MARK	DESCRIPTION	DATE	APPR.
1	REV IN ACCORDANCE WITH AMDT 0004	DEC 2017

HURRICANE & STORM DAMAGE REDUCTION
RARITAN BAY & SANDY HOOK BAY
PHASE II, CONTRACT 4
FORT MONMOUTH, NJ

SANITARY CROSSING #2
CAMPBELL AVENUE

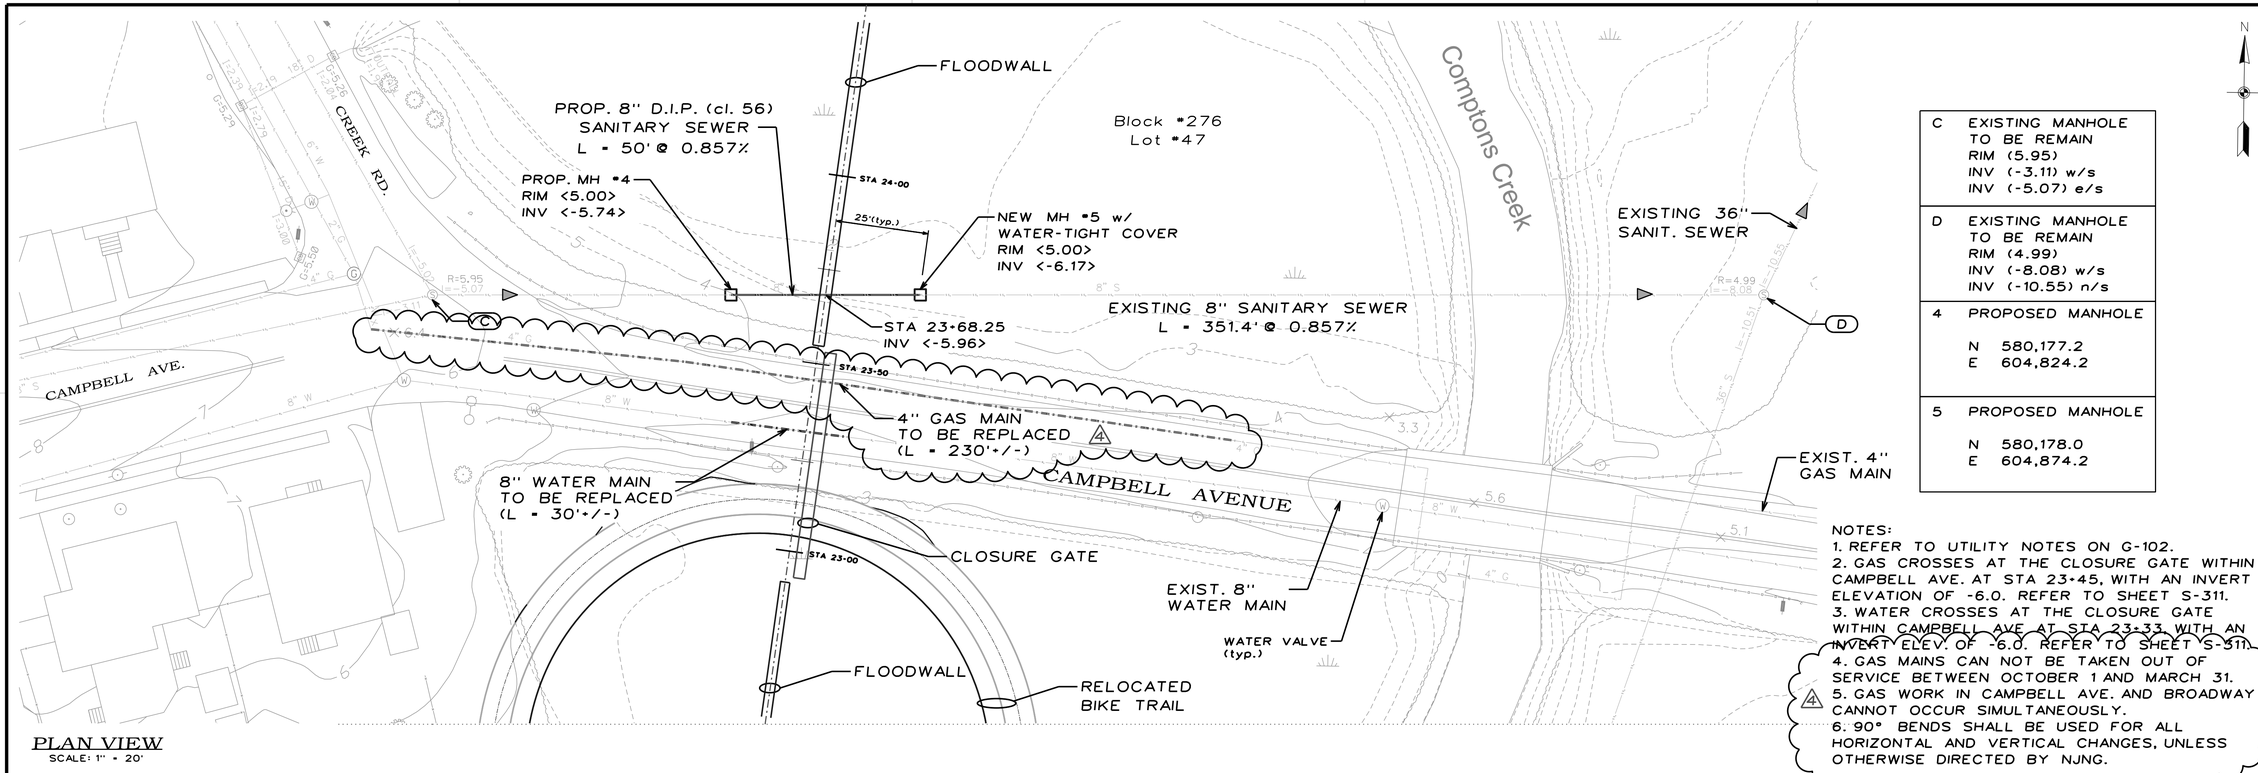
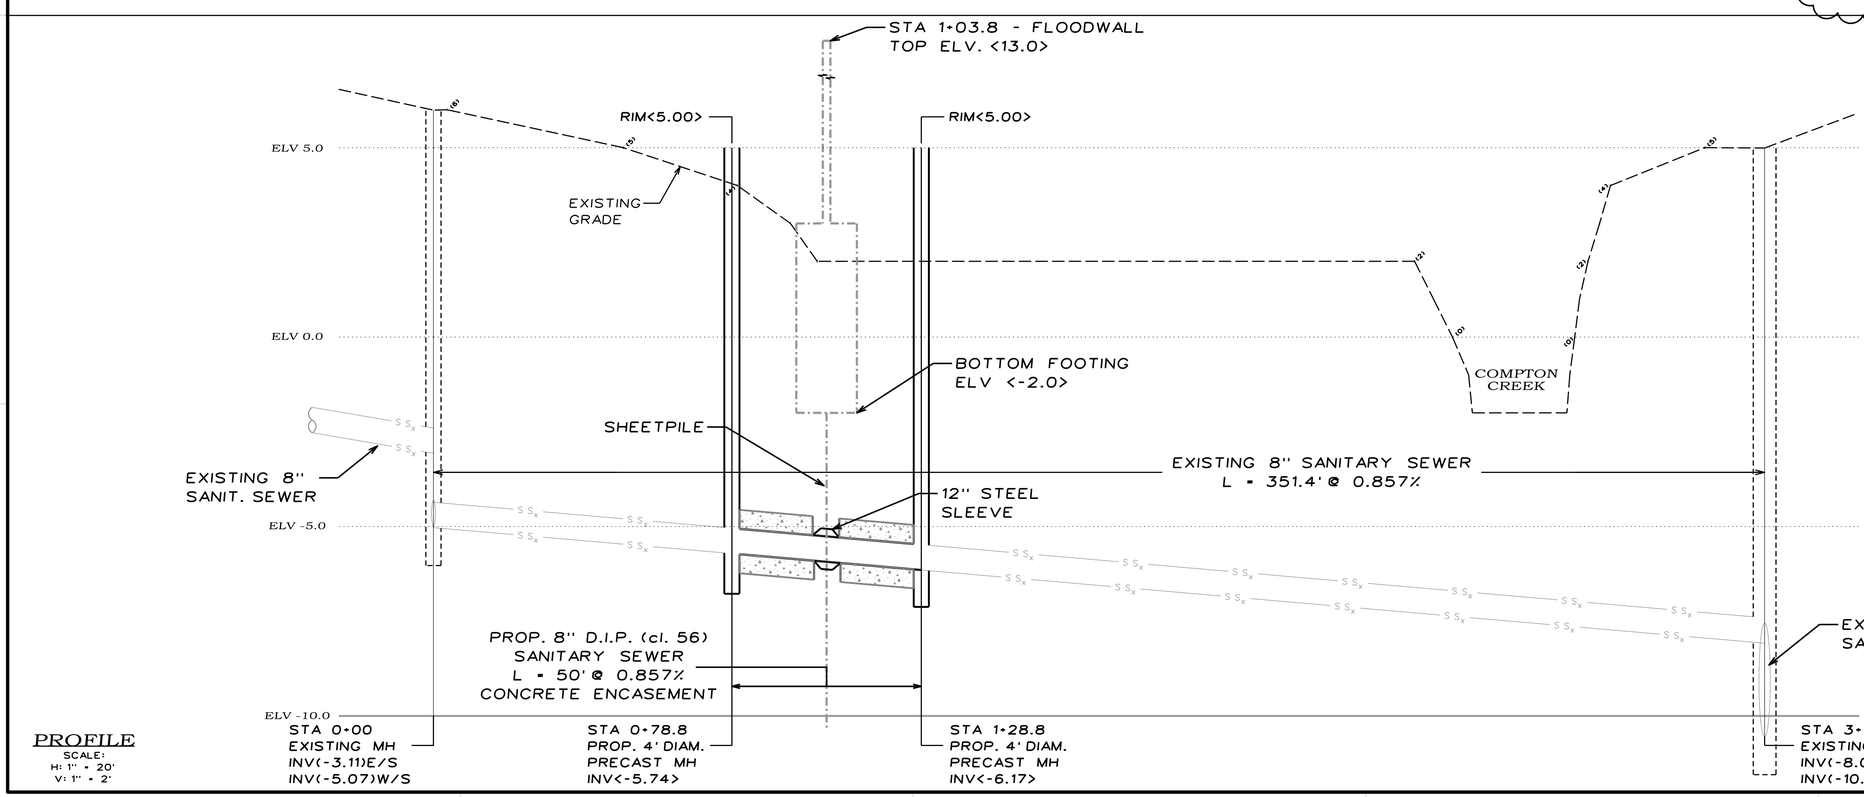
MARK	DESCRIPTION	DATE	APPR.
4	rev STA in utility note	8/15/17

NOTES:
1. REFER TO UTILITY NOTES ON G-102.
2. GAS CROSSES AT THE CLOSURE GATE WITHIN CAMPBELL AVE. AT STA 23+45, WITH AN INVERT ELEVATION OF -6.0. REFER TO SHEET S-311.
3. WATER CROSSES AT THE CLOSURE GATE WITHIN CAMPBELL AVE AT STA 23+33, WITH AN INVERT ELEV. OF -6.0. REFER TO SHEET S-311.
4. GAS MAINS CAN NOT BE TAKEN OUT OF SERVICE BETWEEN OCTOBER 1 AND MARCH 31.
5. GAS WORK IN CAMPBELL AVE. AND BROADWAY CANNOT OCCUR SIMULTANEOUSLY.
6. 90° BENDS SHALL BE USED FOR ALL HORIZONTAL AND VERTICAL CHANGES, UNLESS OTHERWISE DIRECTED BY NJNG.

SANITARY CROSSING #3
BROADWAY

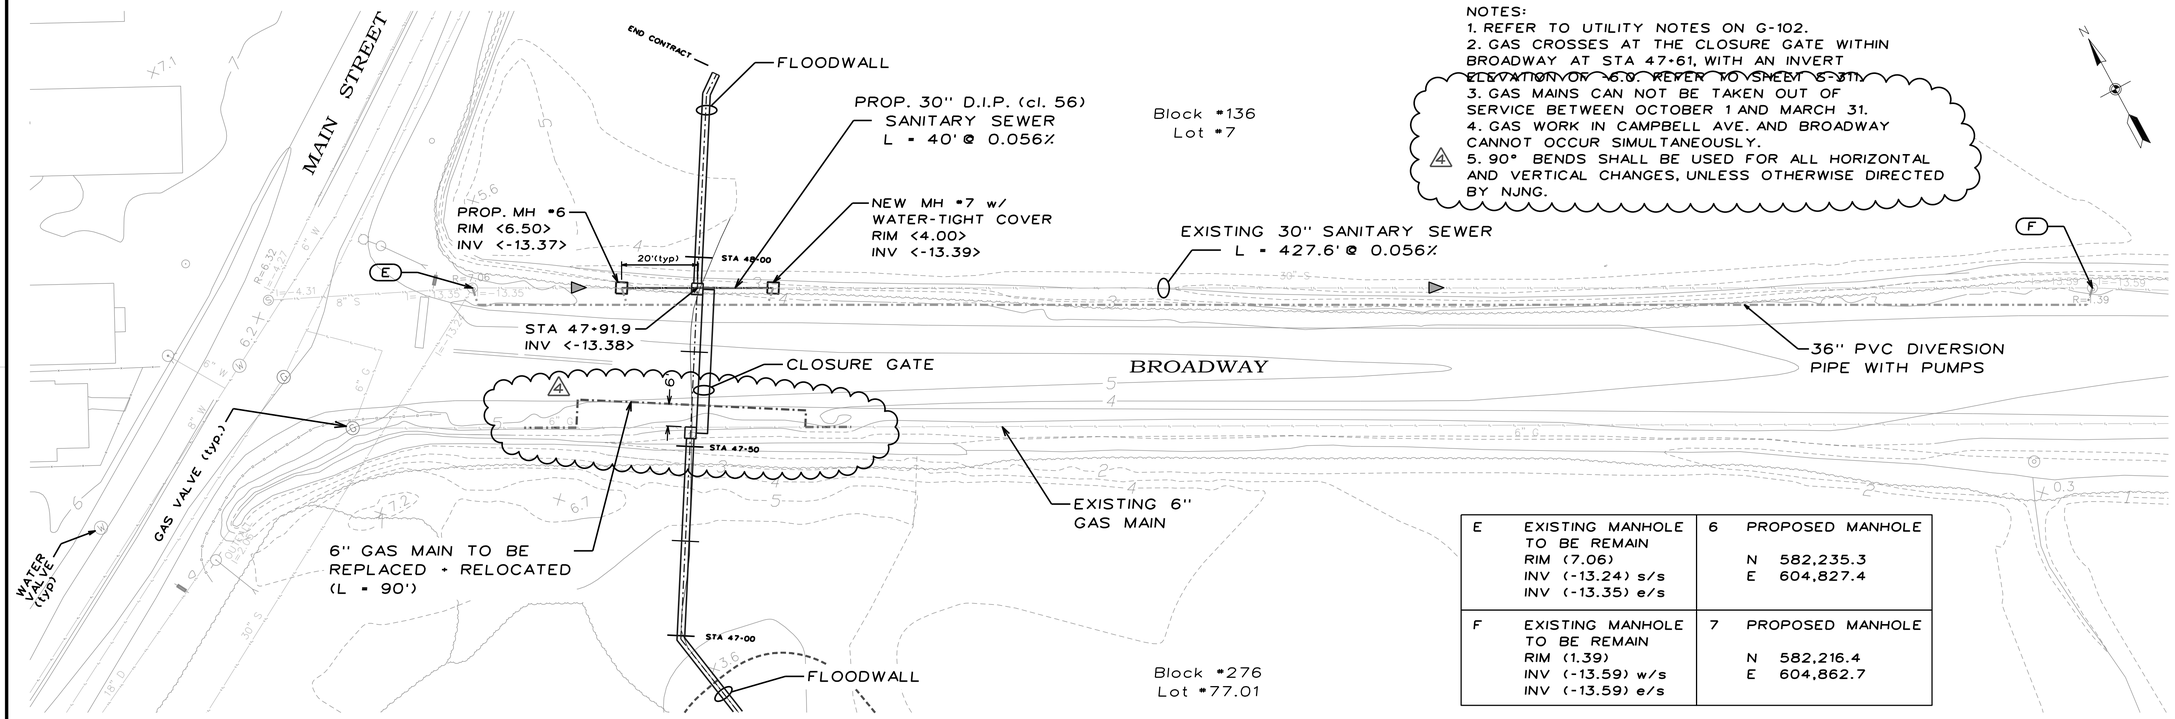
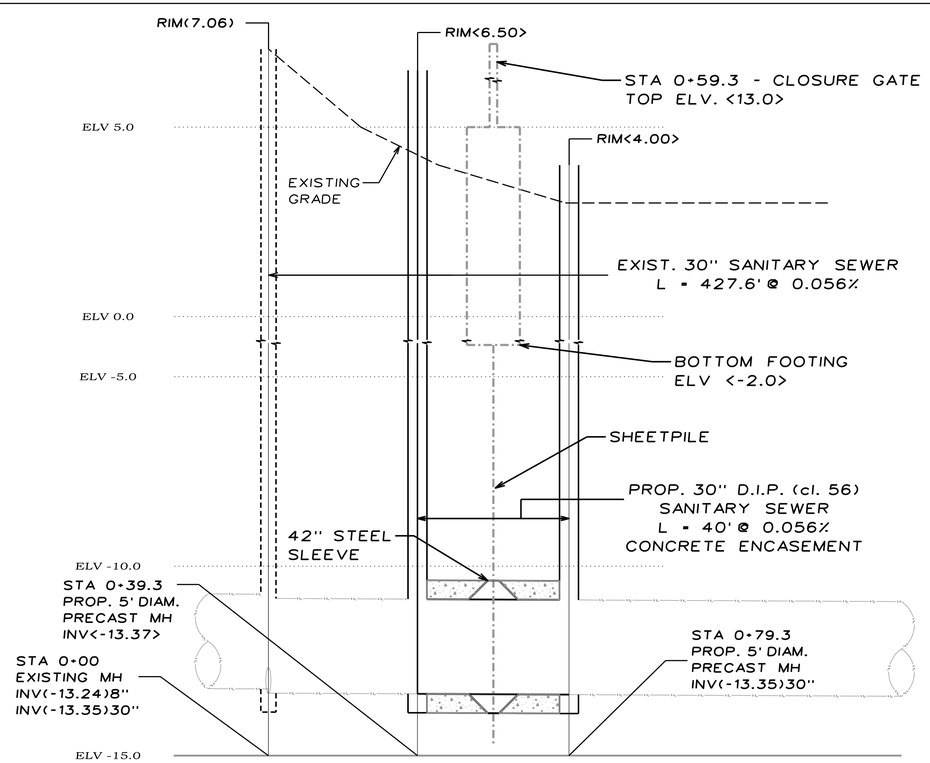
MARK	DESCRIPTION	DATE	APPR.
4	NJNG comments	10/21/17

NOTES:
1. REFER TO UTILITY NOTES ON G-102.
2. GAS CROSSES AT THE CLOSURE GATE WITHIN BROADWAY AT STA 47+61, WITH AN INVERT ELEVATION OF <6.0>. REFER TO SHEET G-311.
3. GAS MAINS CAN NOT BE TAKEN OUT OF SERVICE BETWEEN OCTOBER 1 AND MARCH 31.
4. GAS WORK IN CAMPBELL AVE. AND BROADWAY CANNOT OCCUR SIMULTANEOUSLY.
5. 90° BENDS SHALL BE USED FOR ALL HORIZONTAL AND VERTICAL CHANGES, UNLESS OTHERWISE DIRECTED BY NJNG.

FLOODWALL PLAN
OVERVIEW PART 1

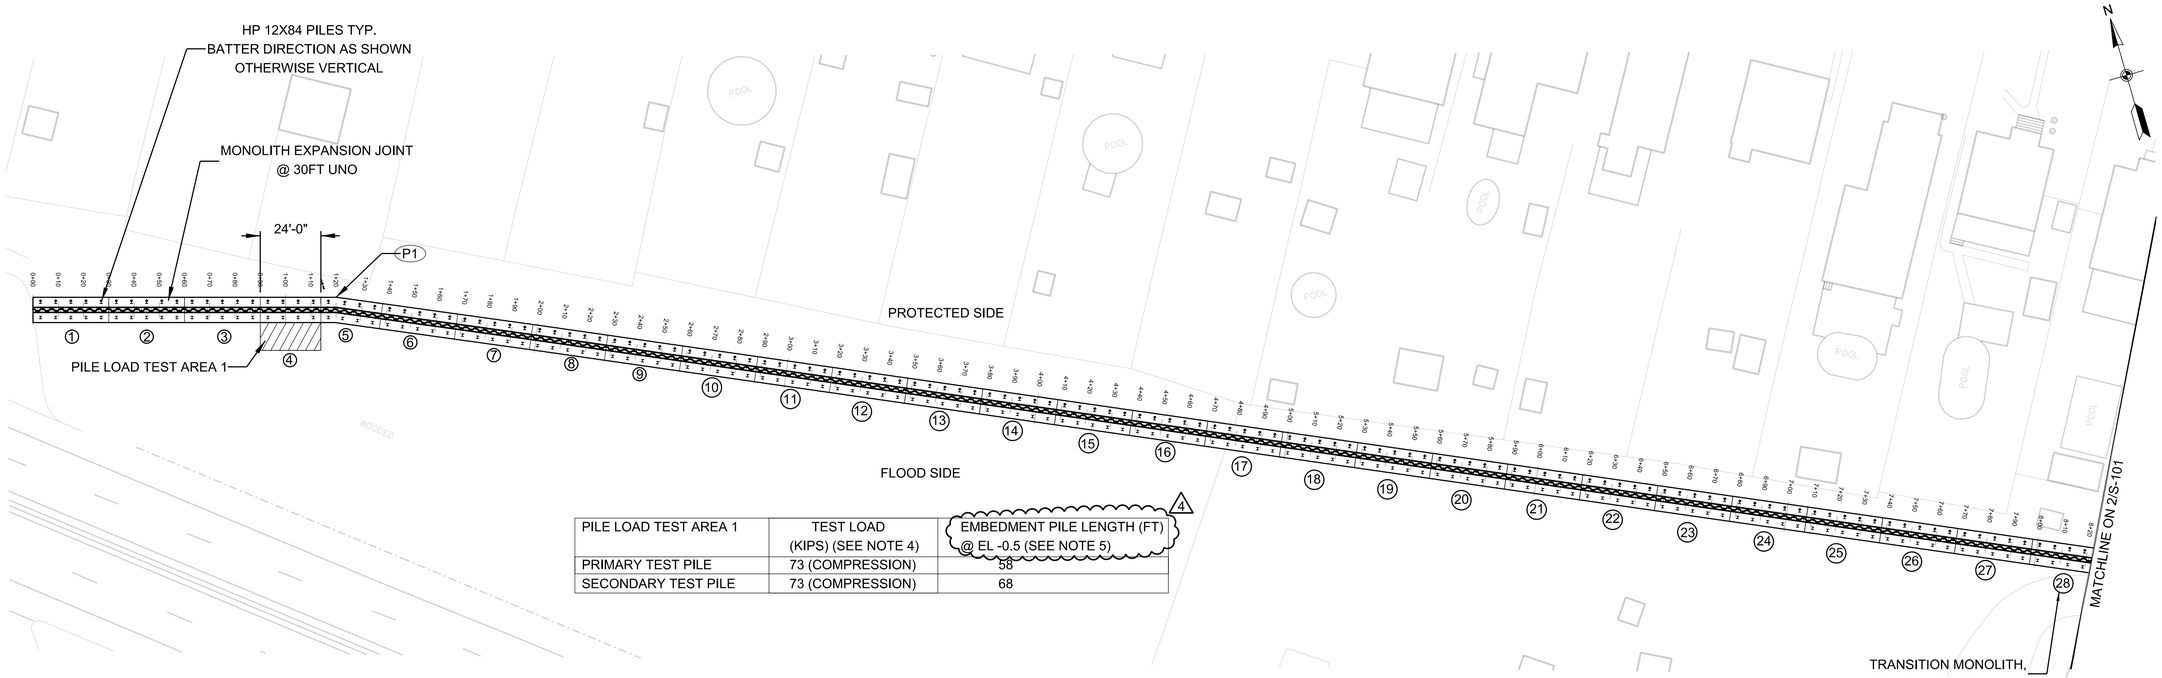
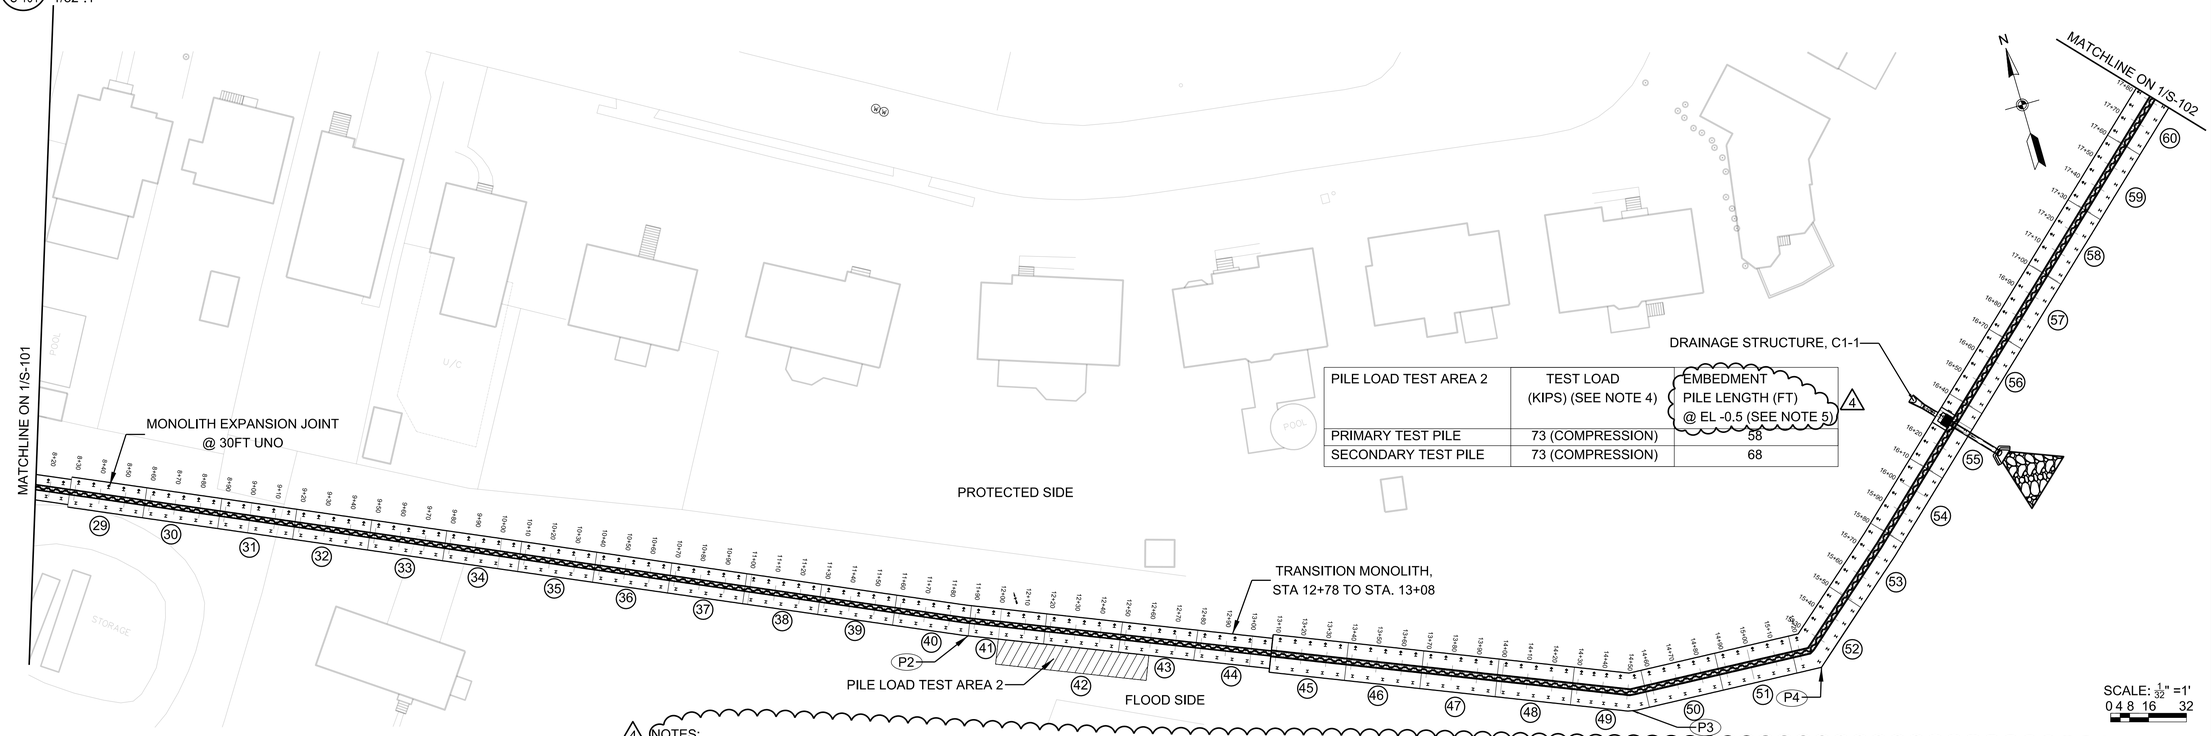
MARK	DESCRIPTION	DATE	APPR.	MARK	DESCRIPTION	DATE	APPR.
4	PILE LENGTH NOTE ADDED	DEC 2017

1. BEND POINT DENOTED AS (P#) AND MONOLITH NUMBER DENOTED AS (#)
2. BEND MONOLITHS ARE SHOWN ON SHEETS S-105 AND S-106
3. SHEET PILE CUT-OFF WALL IS AT CENTERLINE OF FLOODWALL STEM UNLESS NOTED OTHERWISE.
4. TEST PILE SHALL BE LOADED TO A MAXIMUM OF 300% OF THE TEST LOAD SHOWN HERE PER SPEC 31 62 16.16
5. CONTRACTOR SHALL ADD ADDITIONAL LENGTH TO THE TEST PILE LENGTH TO ACCOUNT FOR THE DIFFERENCE BETWEEN THE SOIL ELEVATIONS AT THE TEST LOCATIONS AND THE BOTTOM OF THE FLOODWALL. THE CONTRACTOR SHALL INSTALL A CASING AROUND THE PILE FOR THE ADDITIONAL LENGTH AND SHALL REMOVE THE SOIL BETWEEN THE CASING AND THE PILE FOR THIS ADDITIONAL LENGTH.
